SITE PLAN REVIEW AND APPEARANCE BOARD

CITY OF DELRAY BEACH

---STAFF REPORT---

MEETING DATE: March 8, 2017
ITEM: Motor Group (1107 Wallace Drive) – Class V Site Plan For the Construction of a Partial Two-Story 7,558 sq. ft. Building, Parking Lot and Landscaping Improvements

SITE PLAN &
SITE DETAILS

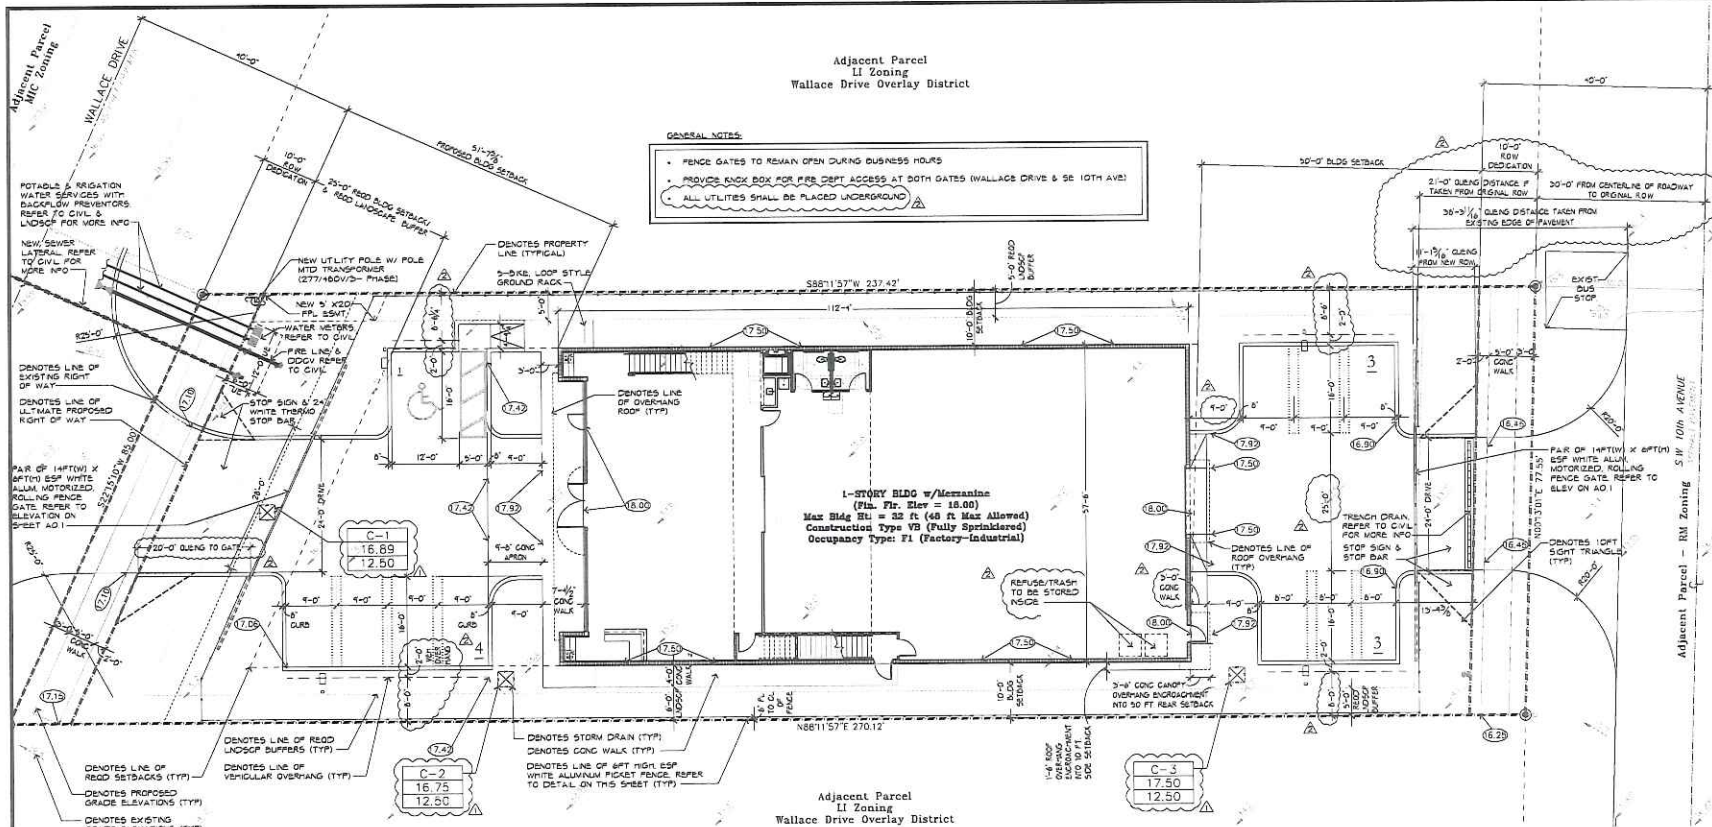
redevelopment of sites. A bike rack accommodating 5 bikes is noted on the site plan, however a detail of the bike rack is not provided and this is noted as a condition of approval.

1. Revise the site plan to show a detail of the proposed bike rack.
2. That additional wall mounted light fixtures with cut-off luminaries are placed on the north and south sides of the building.
3. That a contribution in the amount of \$11,000 towards the City's Bus Shelter Program is paid prior to the issuance of the building permit.
